PLANS AND DOCUMENTS
referred to in the PDA
DEVELOPMENT APPROVAL
Approval no: DEV2020/1150/5
Date: 30-Nov-2022

FLIPSIDE CIRCUS NORTHSORE

AMENDED 9 NOVEMBER 2022
TO REFLECT STAGING AND
AS-CONSTRUCTED UPDATES

2 E-04 EAST ELEVATION 1:125

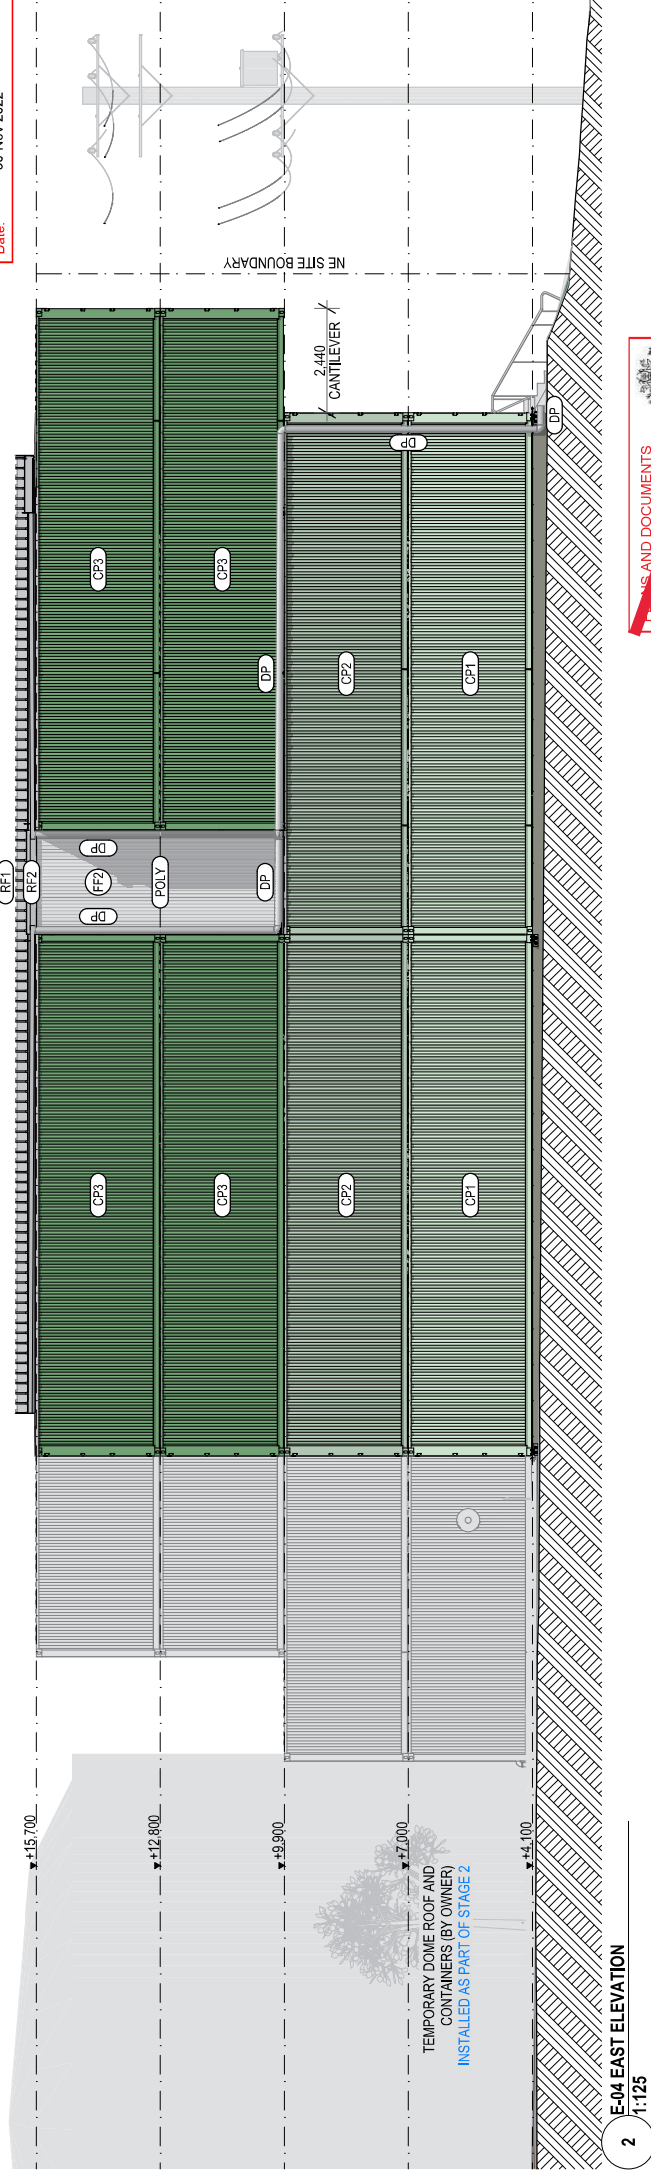
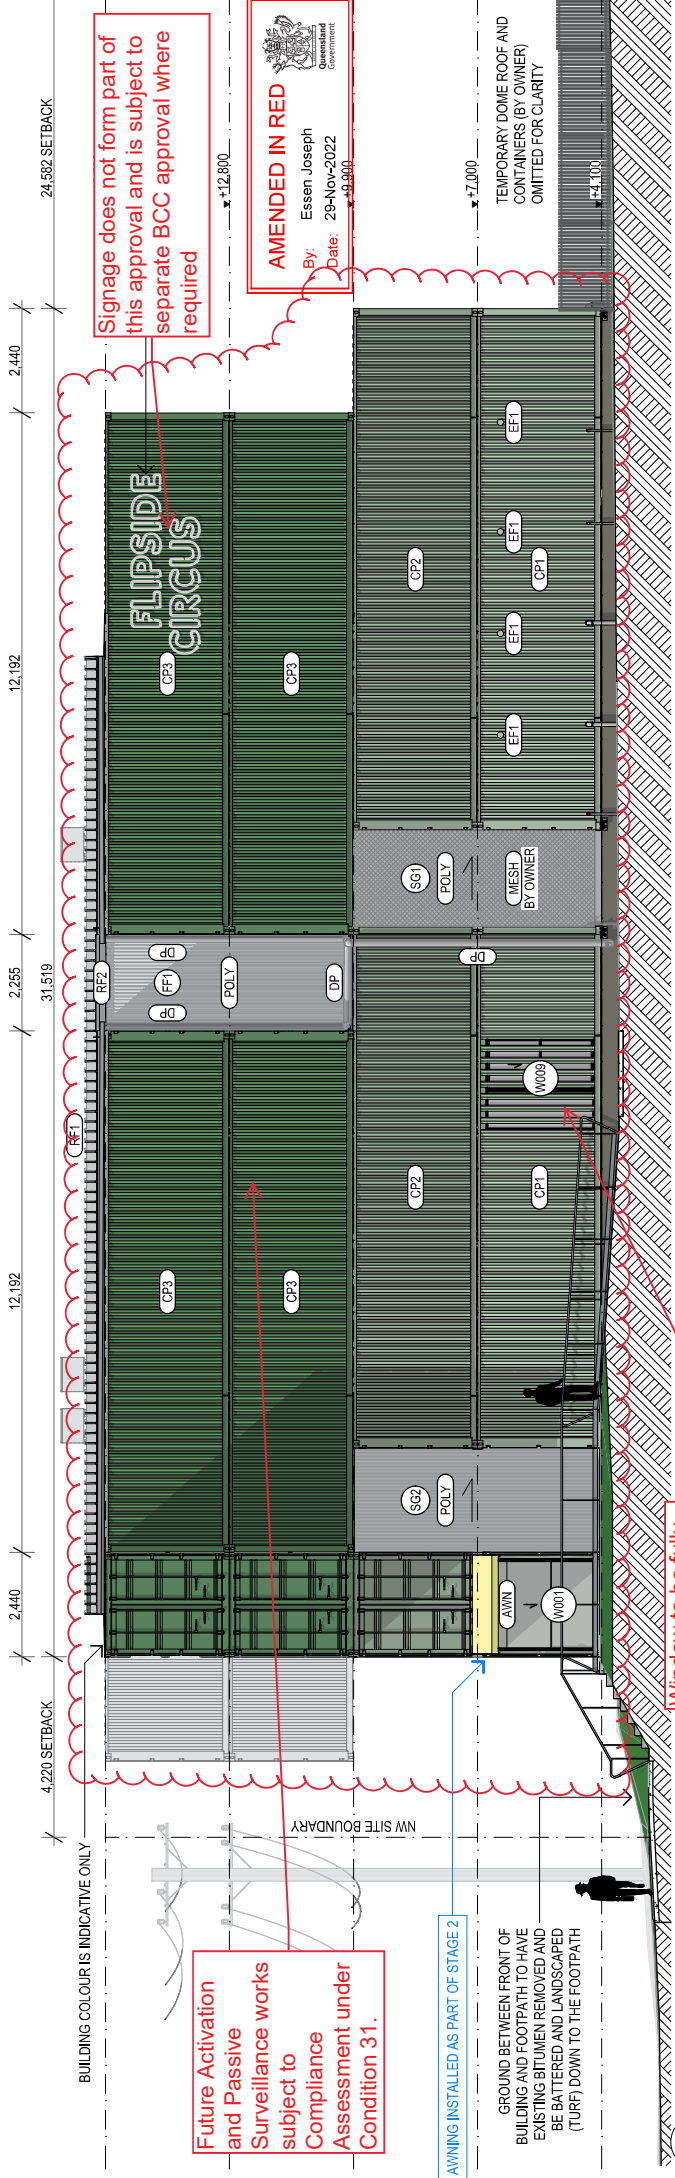
Window to be fully transparent and free from obstructions (E.g. the bars currently shown)

Future Activation and Passive Surveillance works subject to Compliance Assessment under Condition 31.

1 END OF TRIP / NLA PLAN
1:150

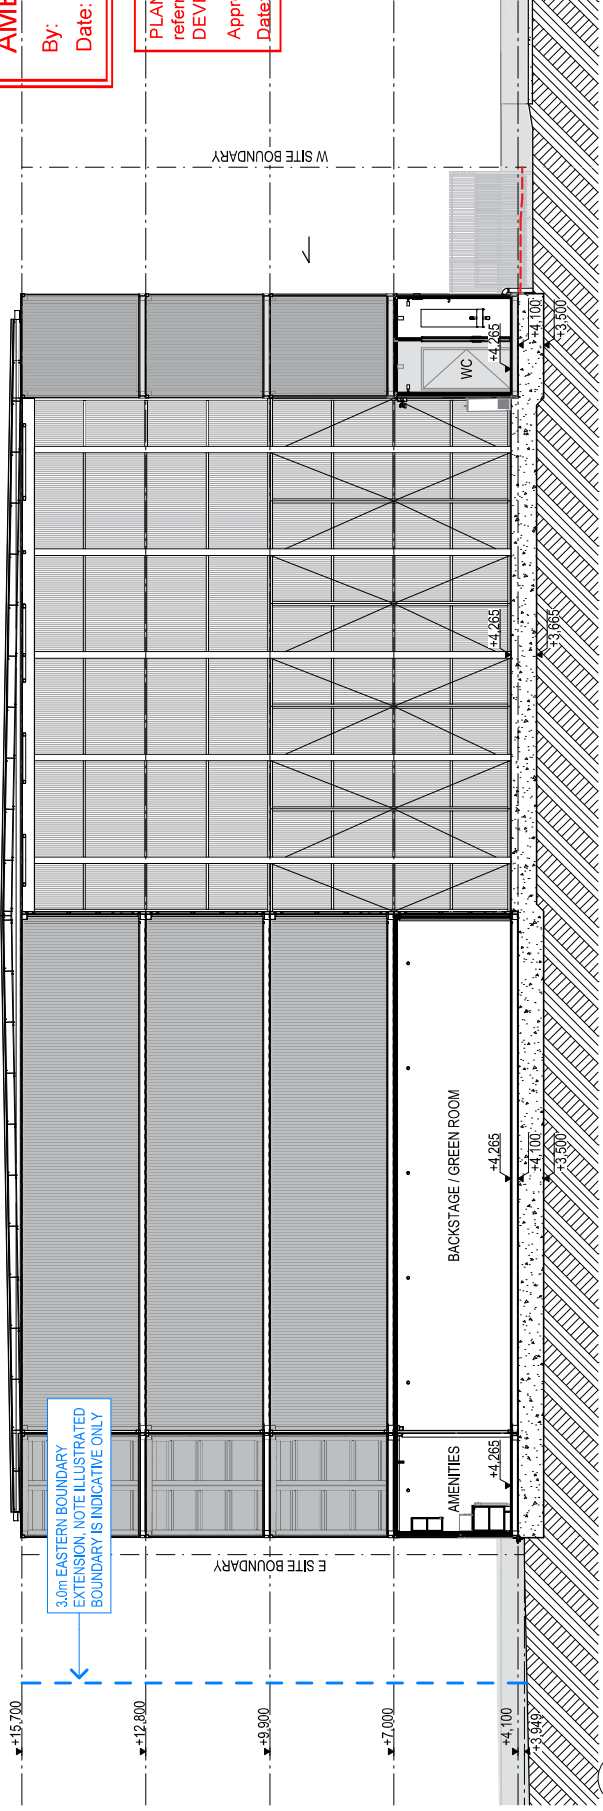
Bicycle parking to be provided in Stage 1 in accordance with approved plan 'End of Trip Plan - Stage 2' prepared by Blok (Drawing 2003, Issue DD16, dated 1 December 2021 (Amended in Red (Amended in Red 13 December 2021))

2 BICYCLE PARKING DETAIL PLAN
1:50

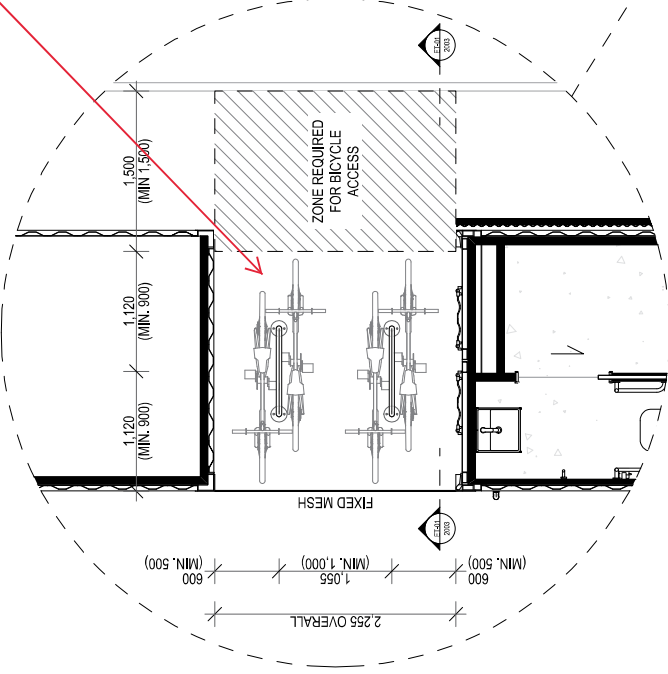
To be delivered in
Stage 1
